State of California – Natural Resources Agency
DEPARTMENT OF FISH AND WILDLIFE
North Central Region
1701 Nimbus Road Suite A
Rancho Cordova, CA 95670
www.wildlife.ca.gov

July 23, 2021

COMMENT LETTER ON THE FOLSOM AND NIMBUS HYDROELECTRIC PROJECTS LOW-IMPACT HYDROPOWER INSTITUTE CERTIFICATION APPLICATION

Figure 1. Inflows and outflows of Folsom Lake. Extracted from USBR 2021.

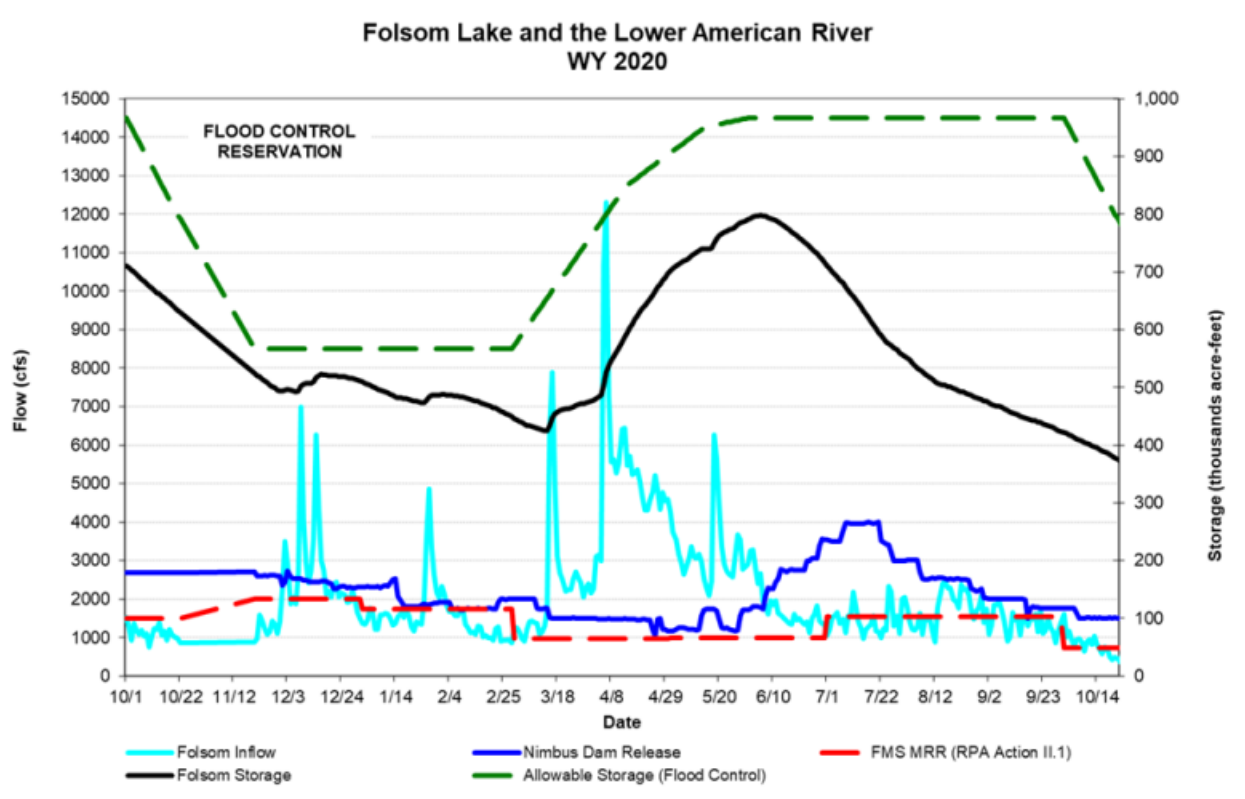
are no longer relevant to this project. CDFW has not evaluated if the MFMS is appropriate for the lower American River below Folsom and USBR has yet to operate the system in accordance with what is outlined in the MFMS. The 2020 water year is a good example of how inflow and outflow patterns can be inconsistent from MFMS MRR flows (Figure 1). Because of this, presenting this flow standard as a science-based management system is disingenuous as Folsom has not operated according to those standards since implementation, and the modified version did not solicit input from leading fisheries science agencies in the development.
